March 31, 1982
AW-82-21

APPLICATION FOR WITHHOLDING PROPRIETARY
INFORMATION FROM PUBLIC DISCLOSURE

SUBJECT: Response to Questions on WCAP-9561, "Bart-A1: A Computer Code for the Best Estimate Analysis of Reflood Transients" (Proprietary)

BART PREDICTION VS. F/S 2714B DATA
6' ELEVATION

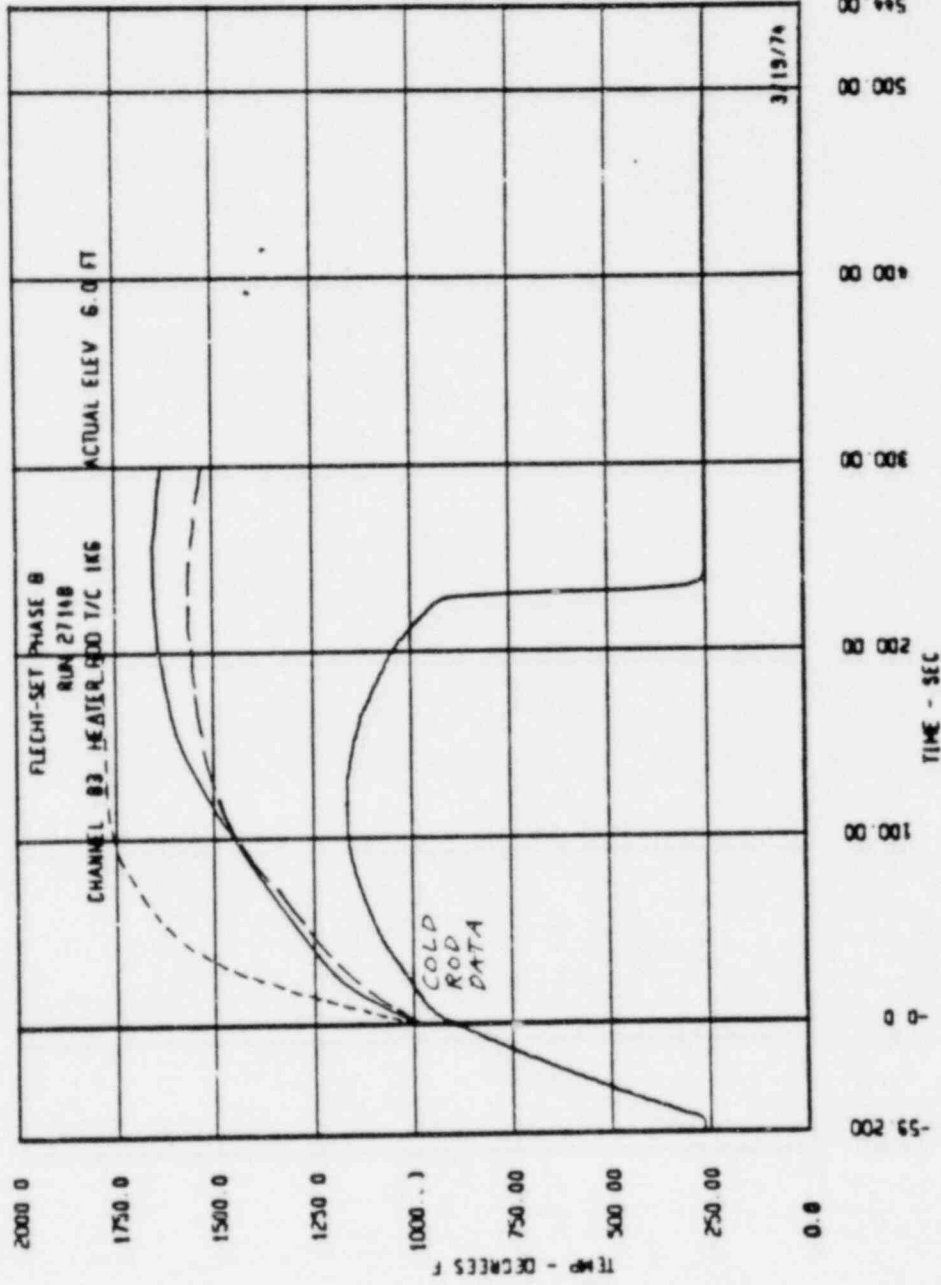
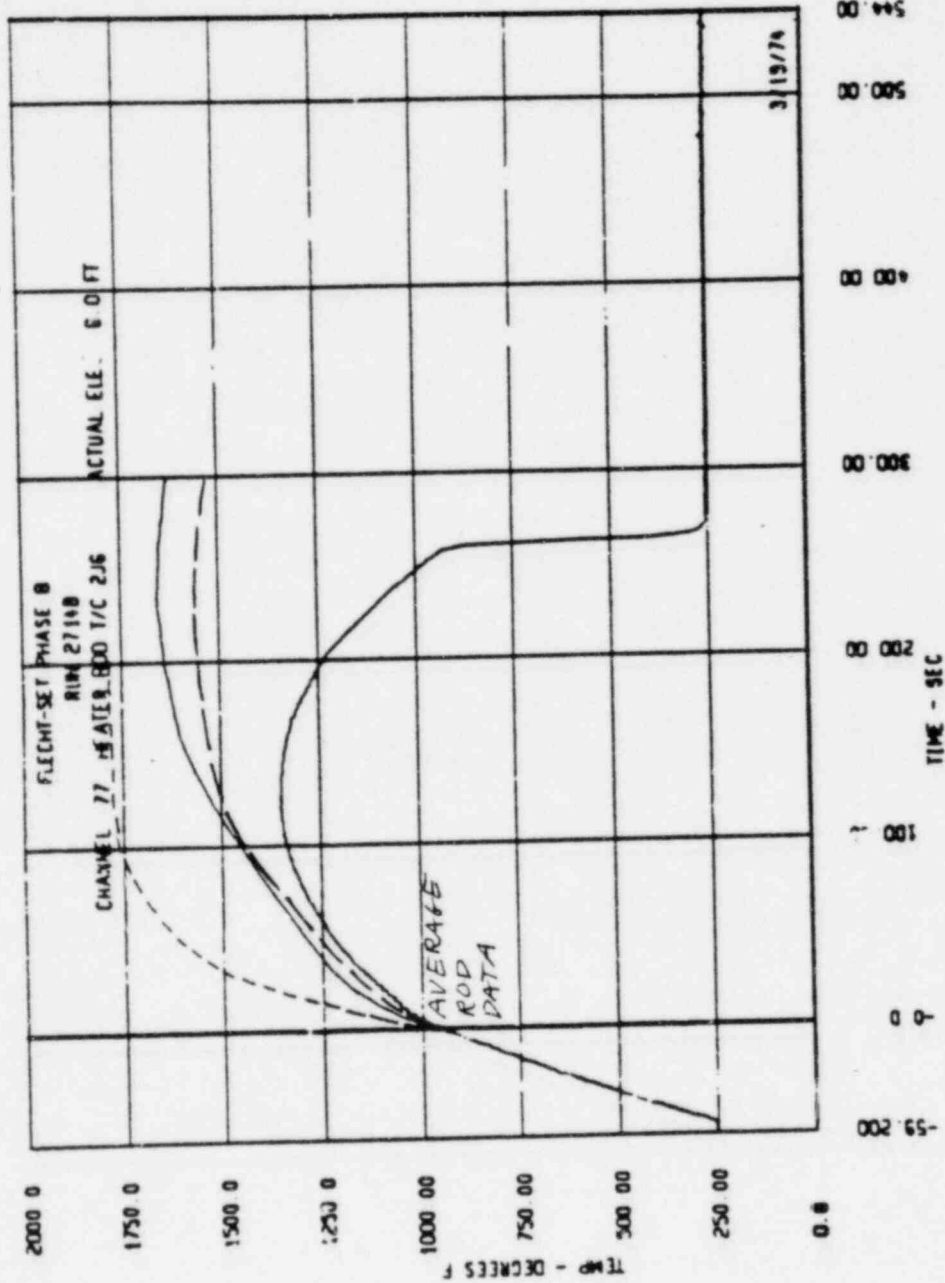
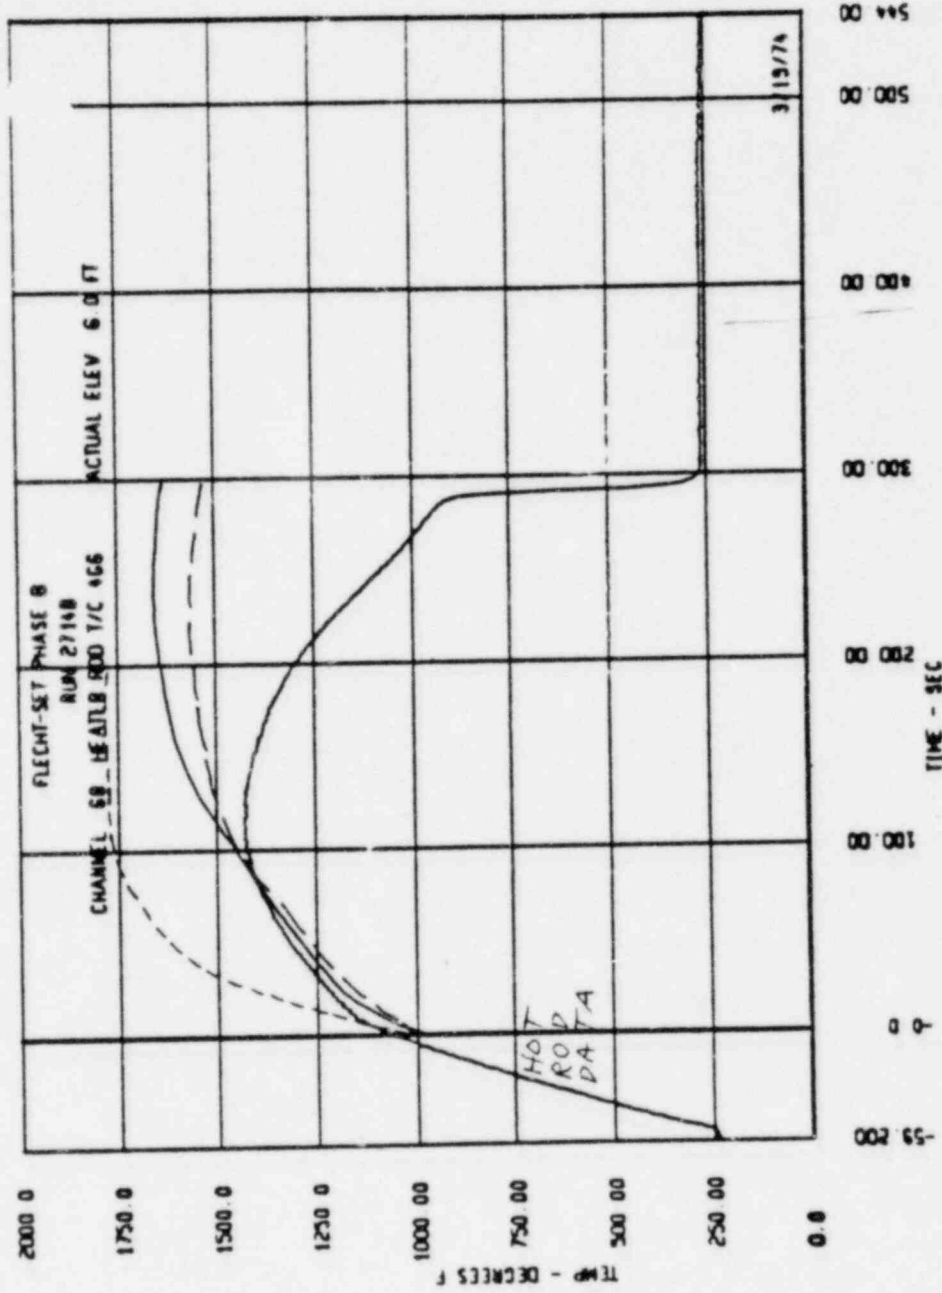
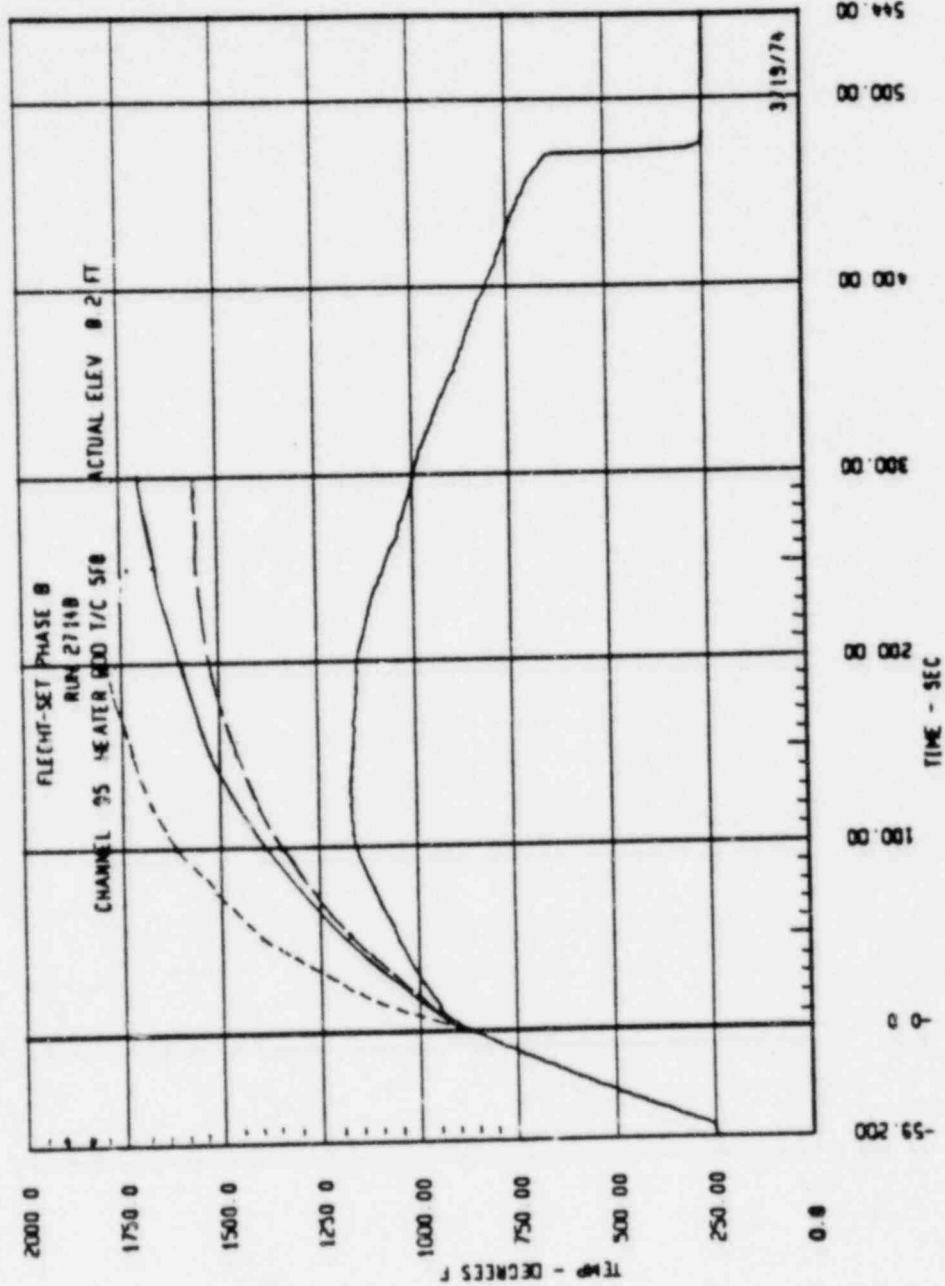
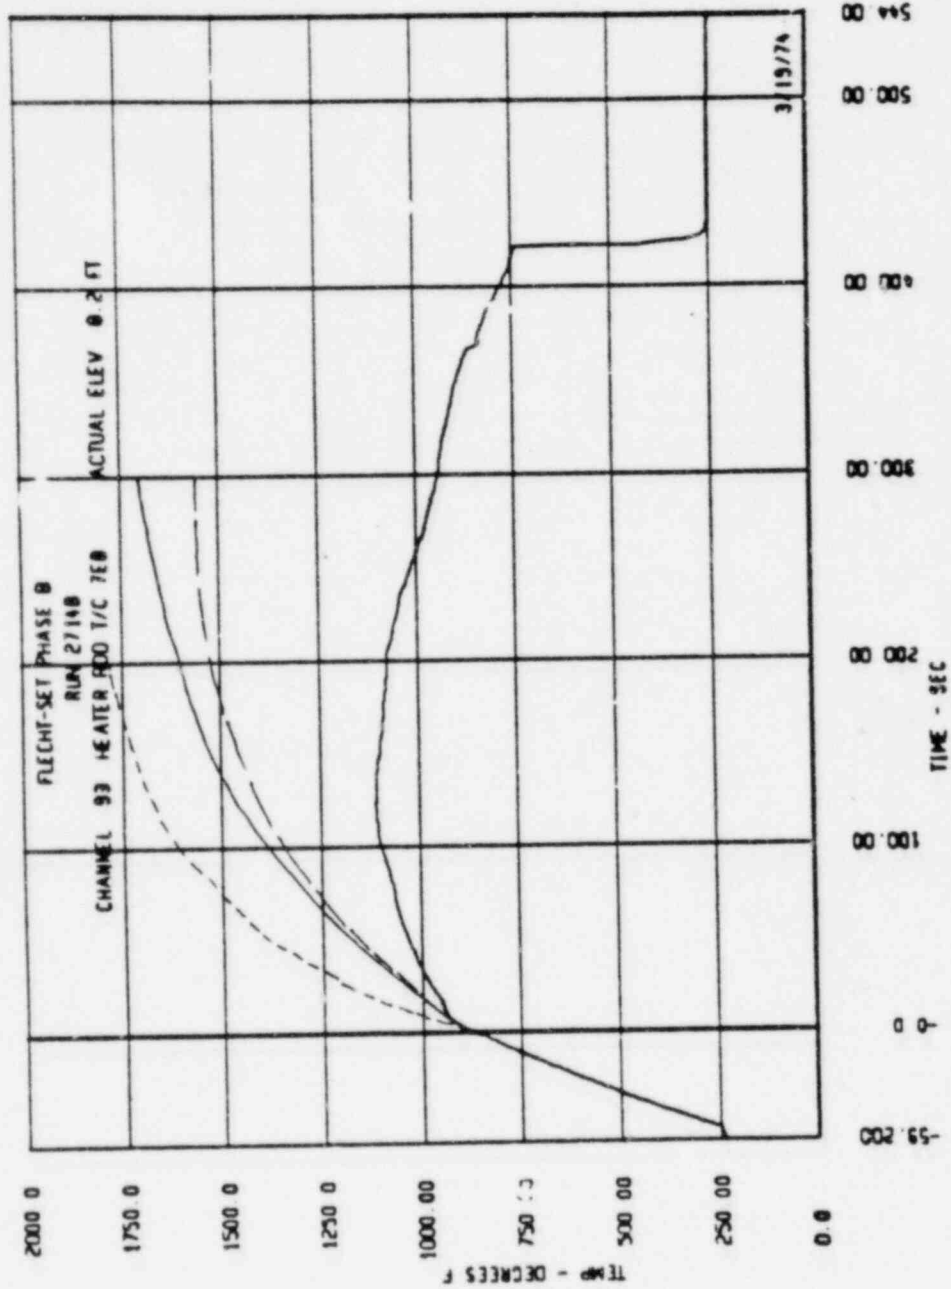
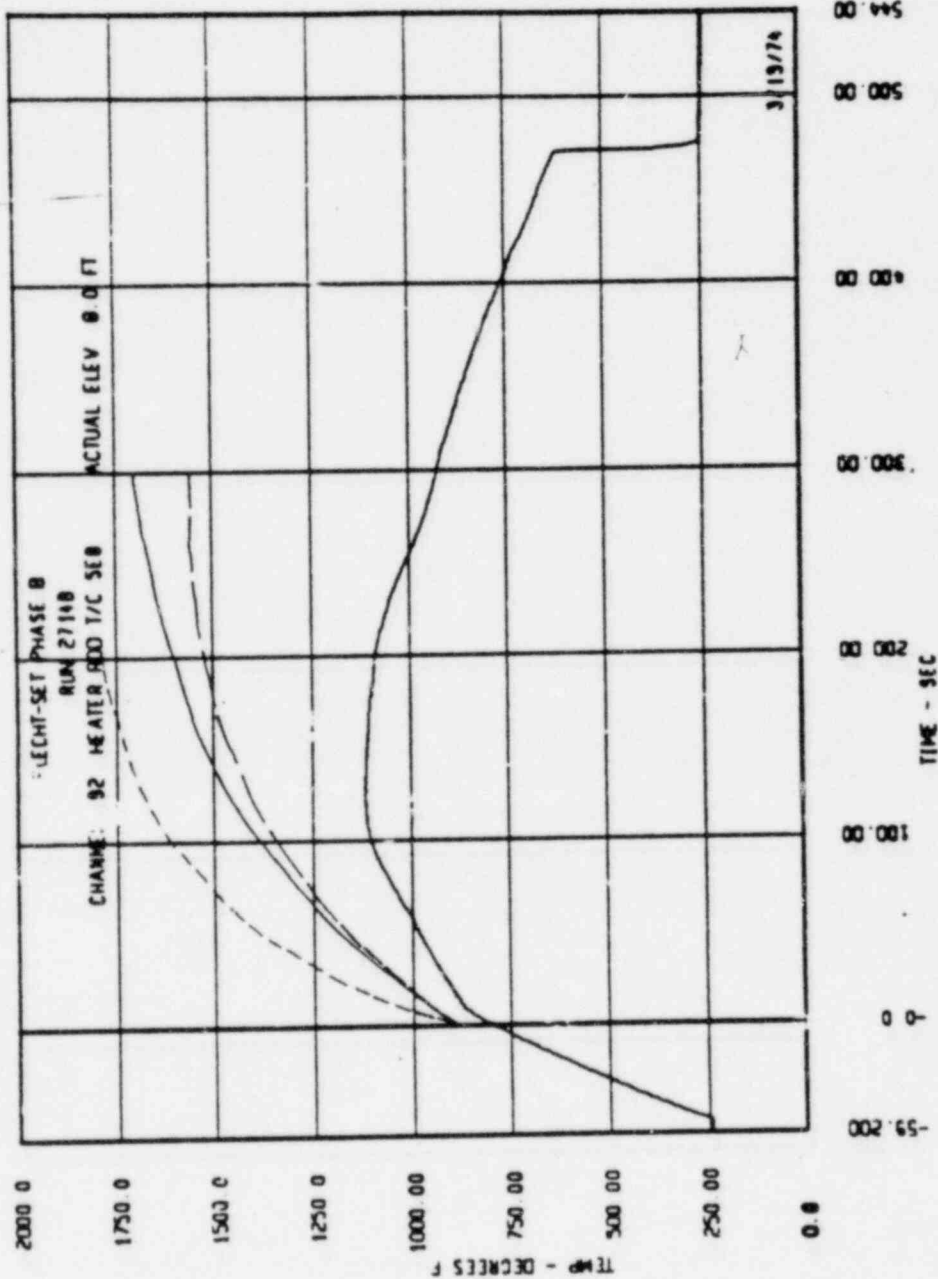
- 2.) The clad wall temperature comparison graphs in Figure 6.2 and 6.5 do not include elevations or rod identification. A more complete and detailed data presentation is needed.

- 3.) How does one account for the substantial clad surface temperature over-prediction of Figure 6.2 and 6.5?

The improvement in peak clad temperature predictions due to the modified flooding rate profiles is shown in the attached plots of clad temperature. These plots give the same basic information as the less explicit Figure 6.2 and 6.5 in the BART - A1 report.

A discrepancy between the accumulator mass depletion and the measured flow totalling 48 pounds at the end of the FS 2714B test has been noted. It translates to a lower calculated flooding rate for the test and a lower input flooding rate for the BART prediction of that test.

As a final exercise, BART was rerun with a flooding rate calculated to include the water unaccounted for in the original test. The further improvement of the BART temperature calculation demonstrates how important an accurate input flooding rate is in determining the accuracy of the entire BART model prediction.
